945 Roselle Ct  
Pittsburgh, PA 15207

## ADDENDA 2

September 11, 2017

Task Order  
Contract No. 33 -  
Glen Hazel Rental  
Assistance  
Demonstration  
(RAD)  
945 Roselle Ct  
Pittsburgh, PA 15207

1 First Floor Plan  
1/8" = 1'-0"

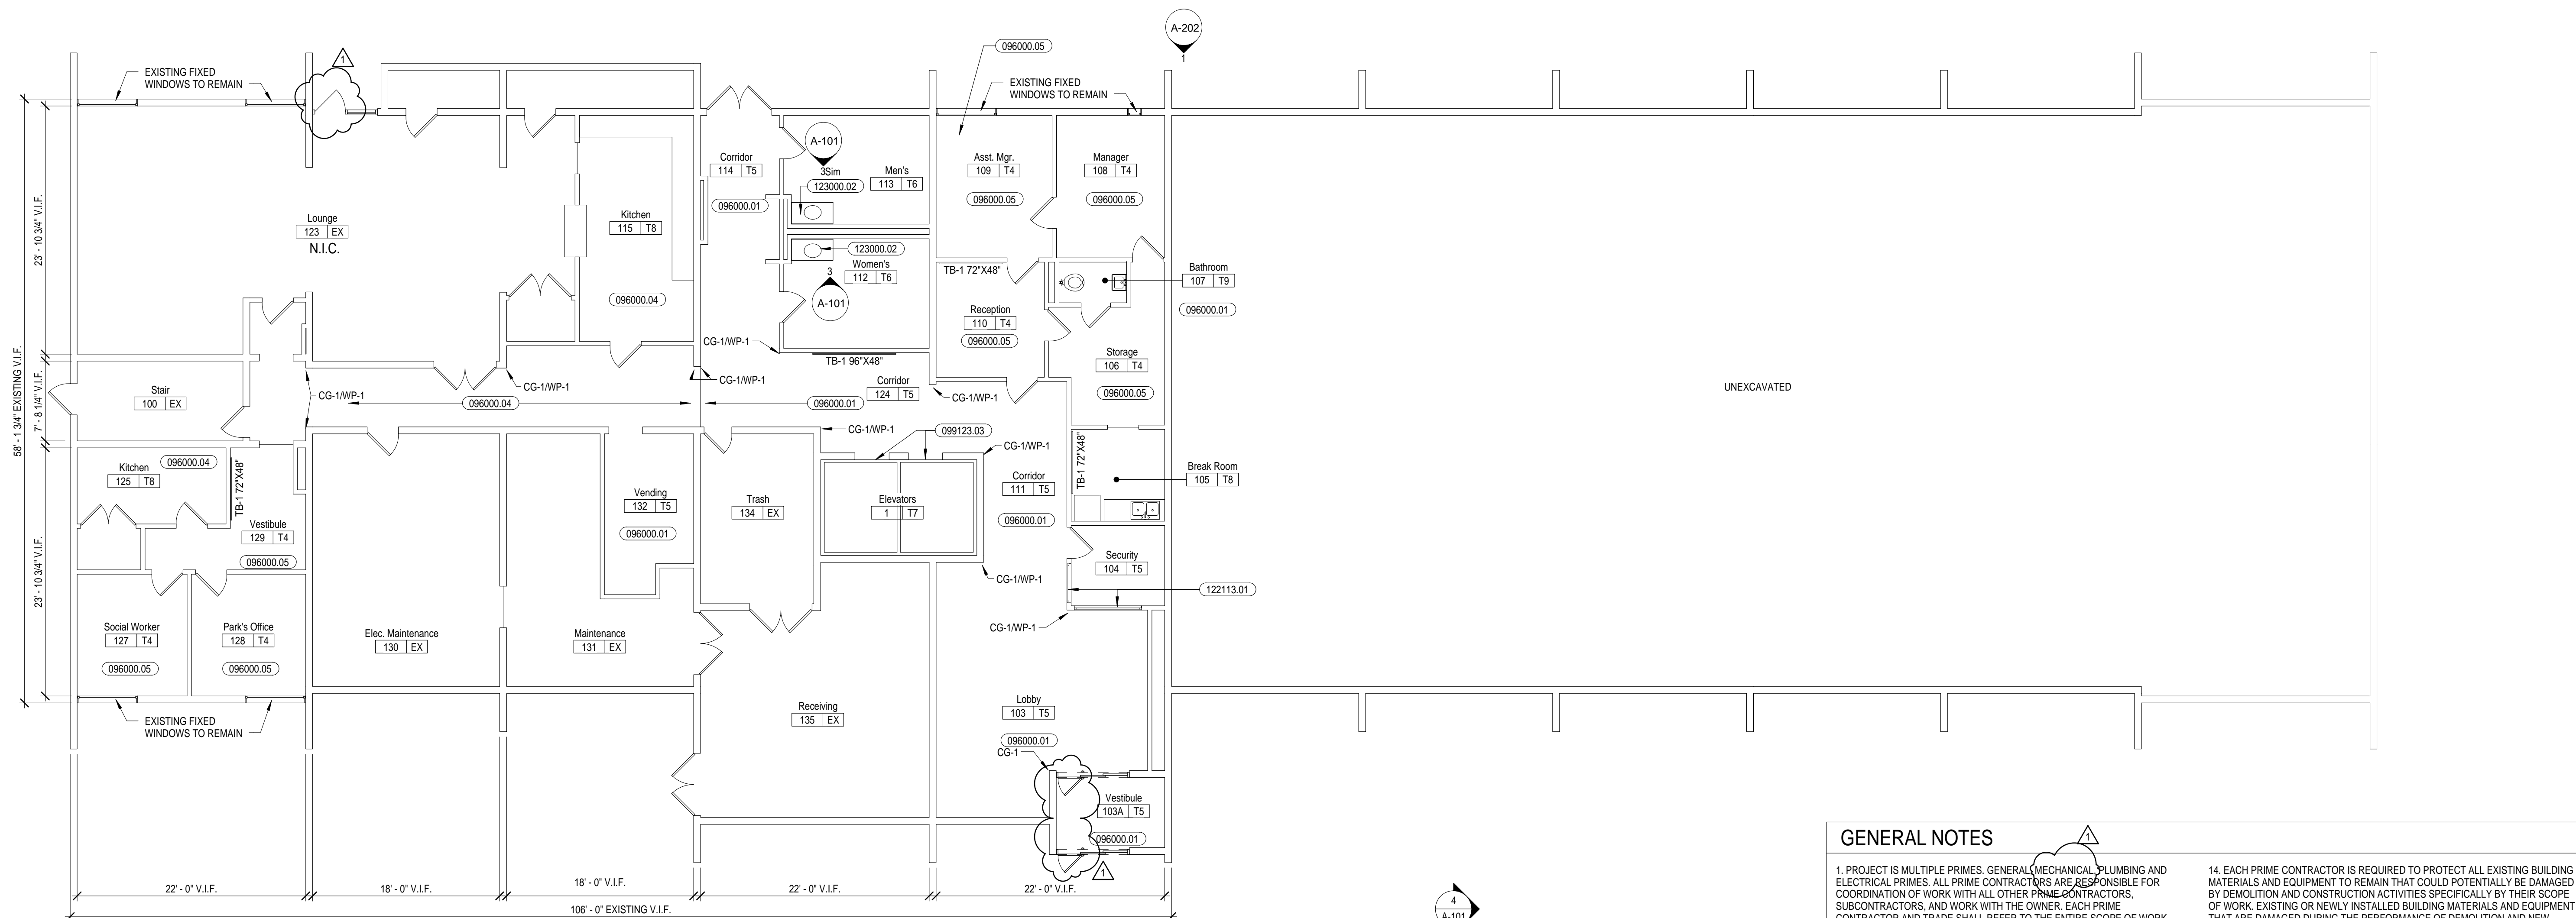
2 Transition Details  
6" = 1'-0"

3 Restroom Vanity - First Floor Only  
1/4" = 1'-0"

4 Typical Vanity Section - First Floor Only  
1" = 1'-0"
